Harrison/Police Station & Court Building – Design Guidance Review Meeting
Project Manager: Kelly Tayara & Ellen Fairleigh

Vincent Road Transfer Station – Conceptual Proposal Review Meeting
Project Manager: Kelly Tayara

Winslow Hotel (PLN50880 SPR CUP) – DRB Review & Recommendation Meeting

**CITY OF BAINBRIDGE ISLAND
DESIGN REVIEW BOARD – REGULAR MEETING
June 3, 2019**

WINSLOW HOTEL
Cutler Anderson Architects

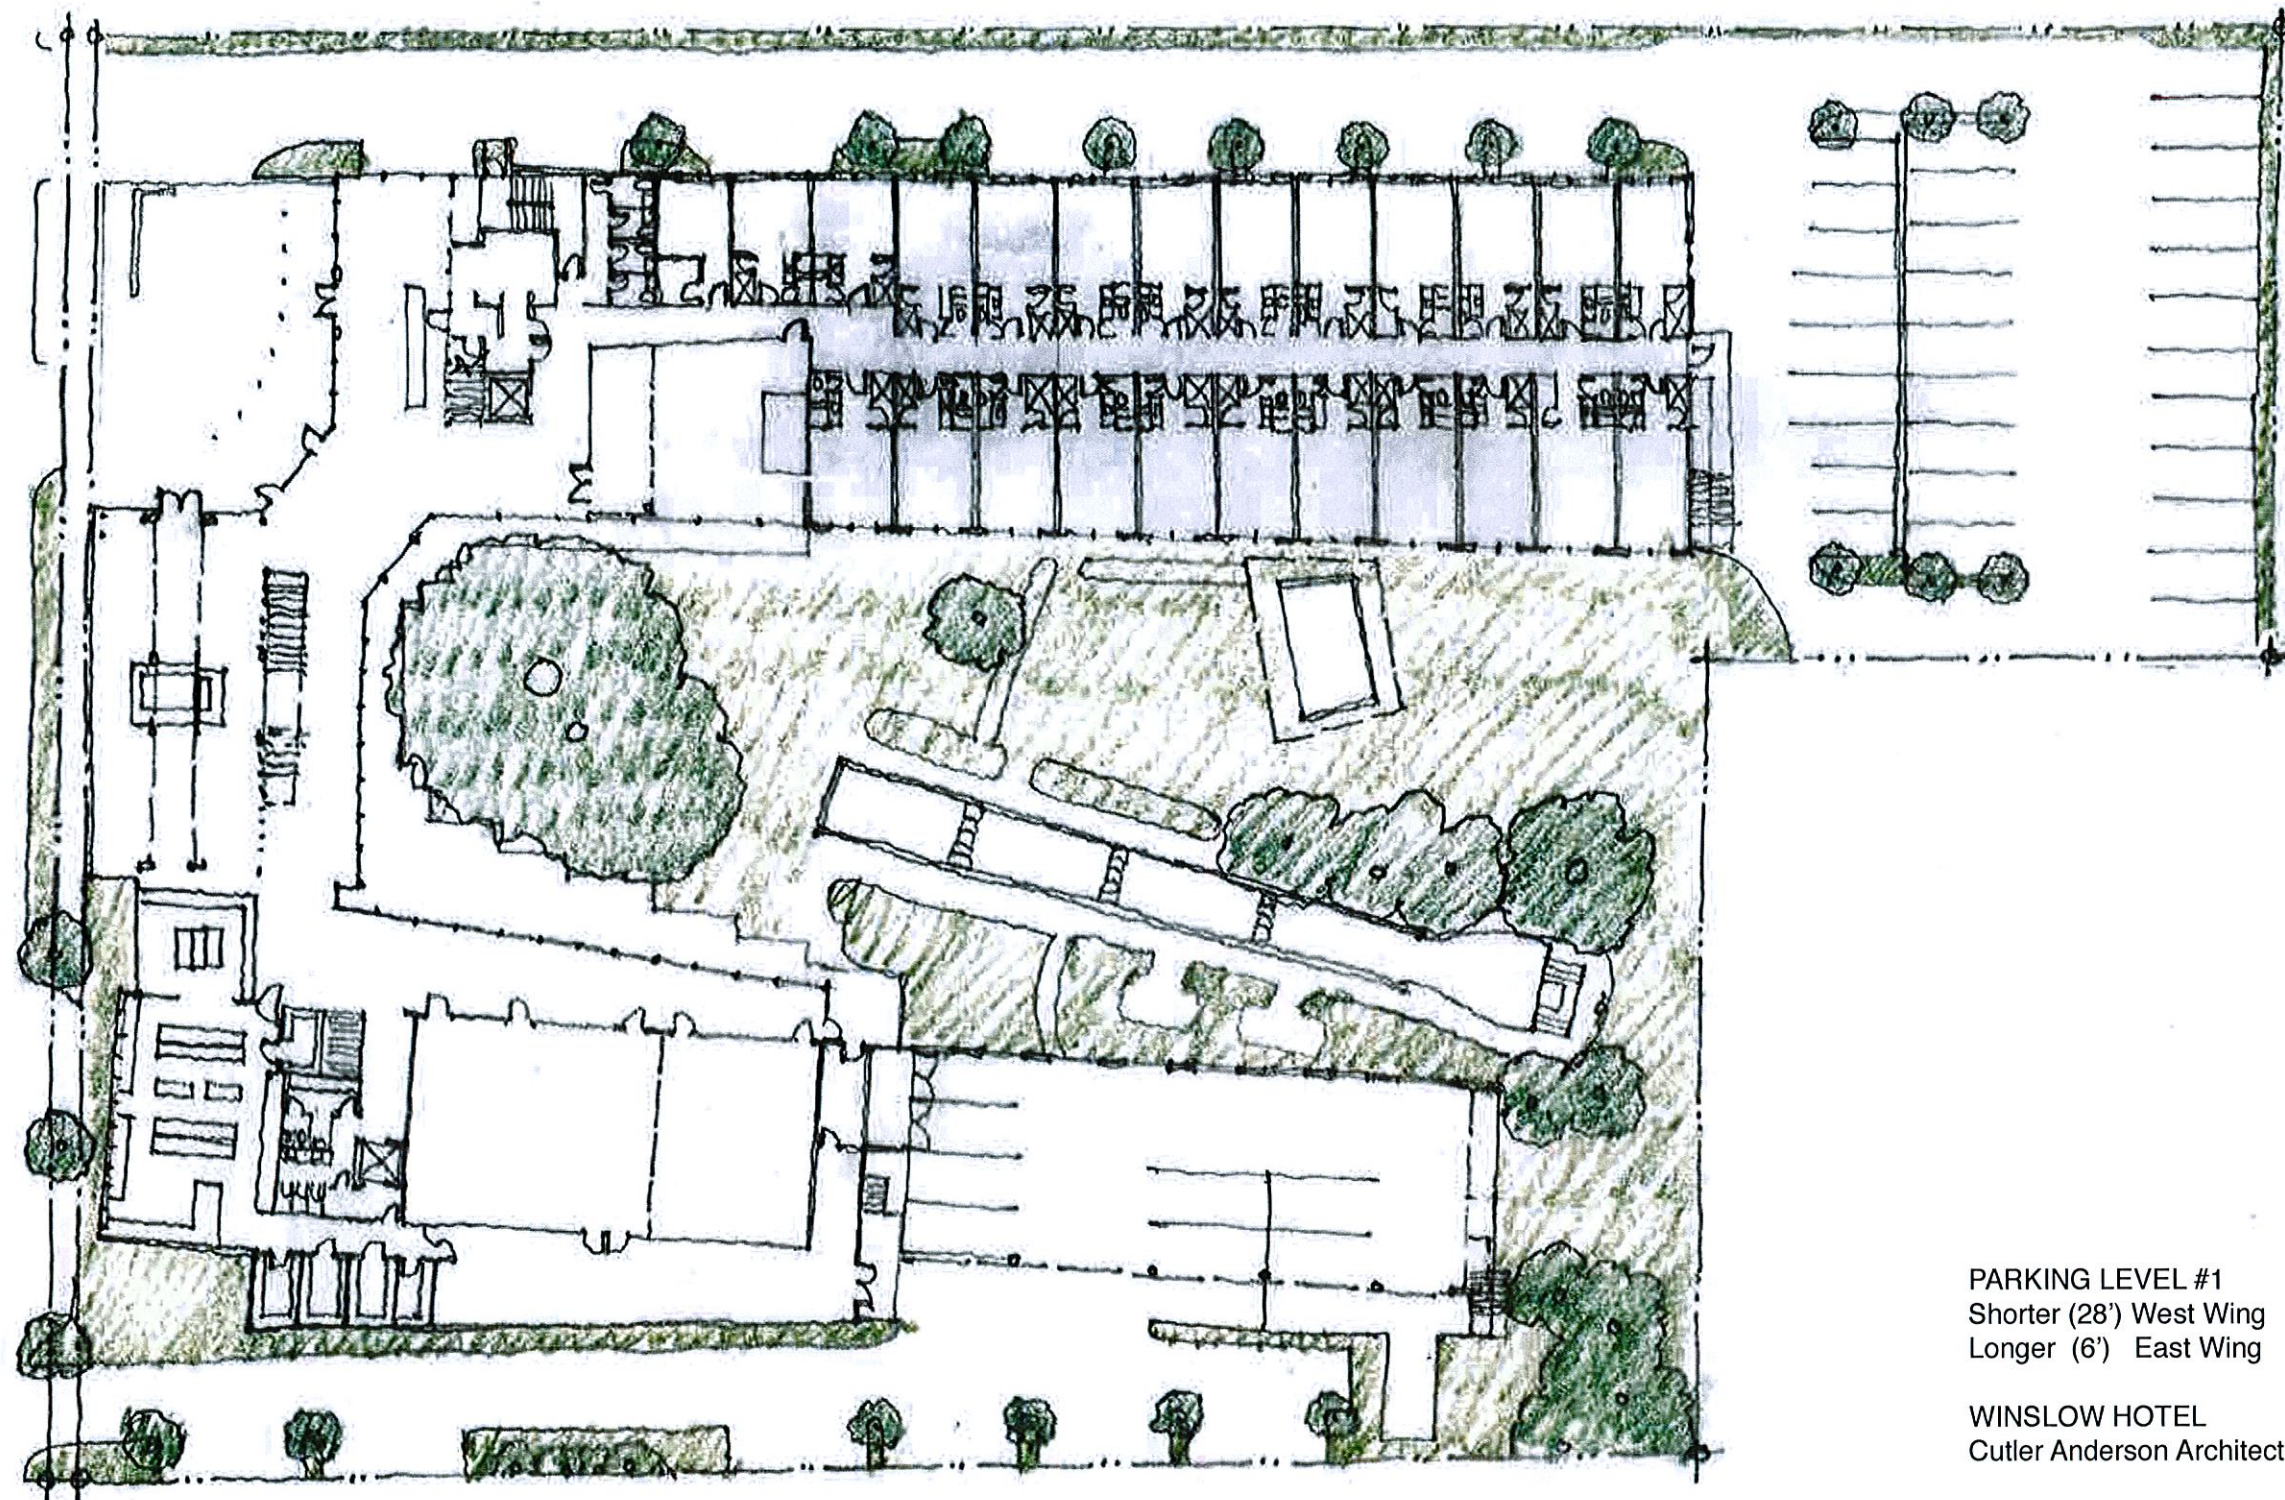
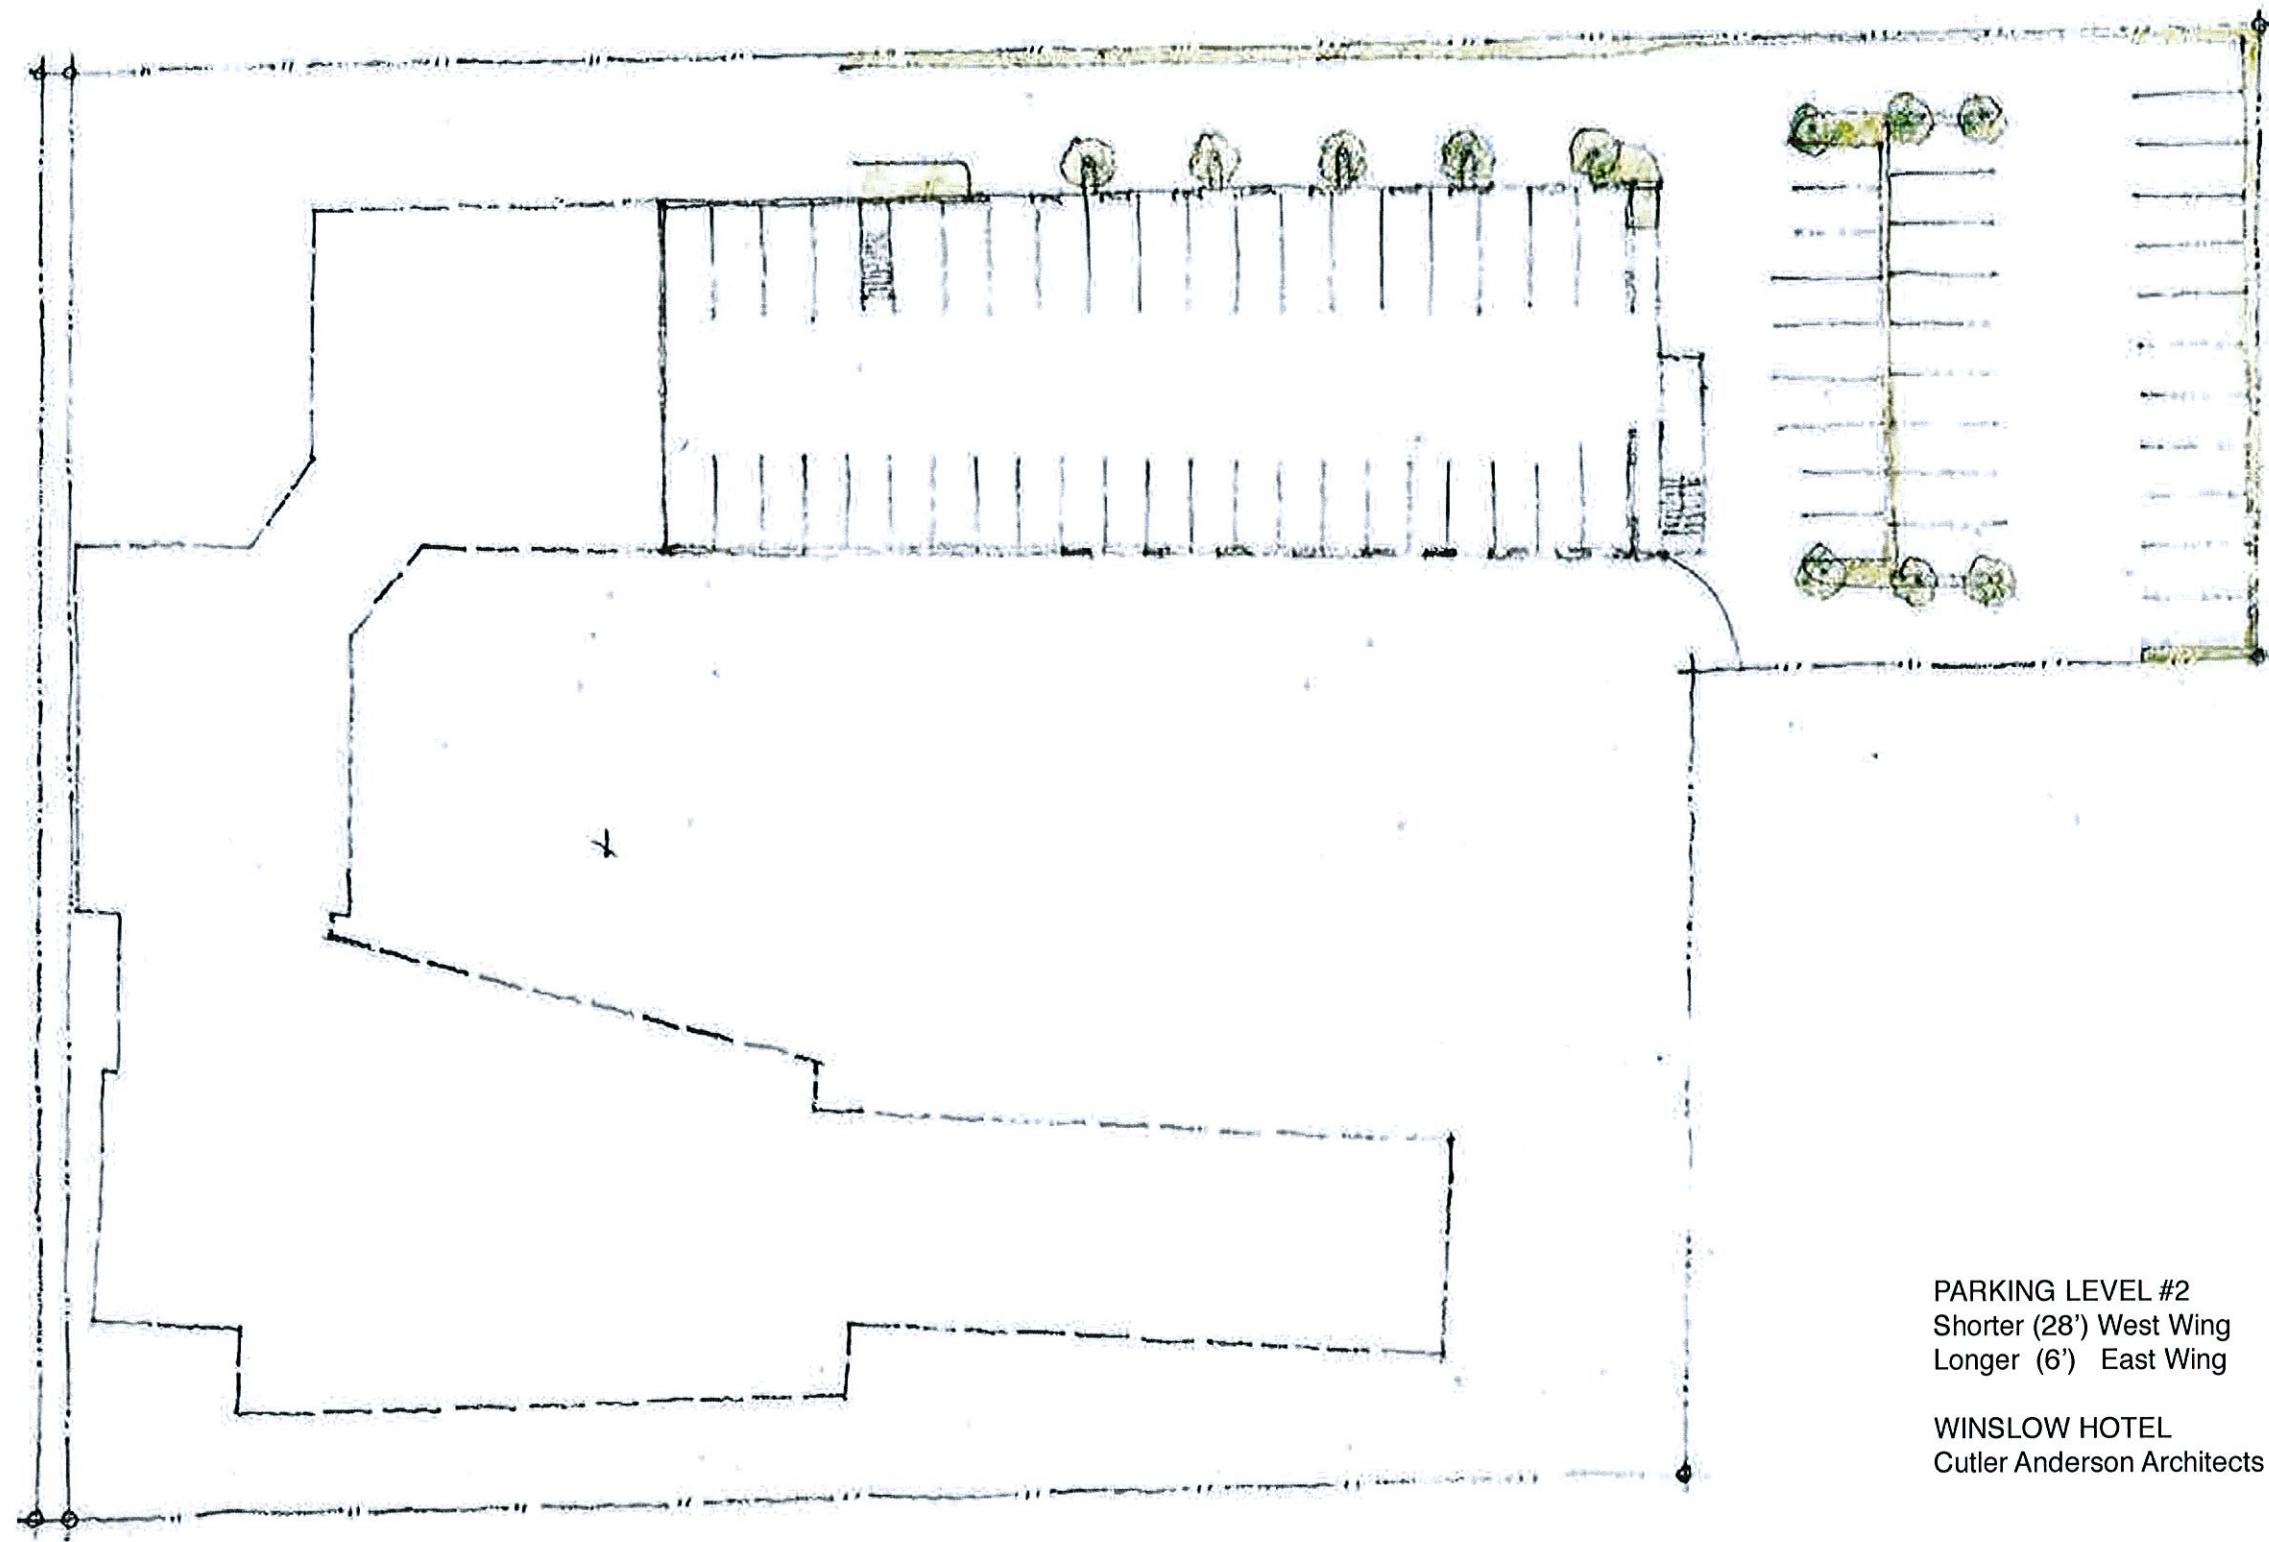
Review & Recommendation of Option 1 -

Motion: I move to recommend approval of the proposed 28-foot reduction to the west wing and 6-foot increase to the east wing.

Dunstan/No 2nd: Passed unanimously
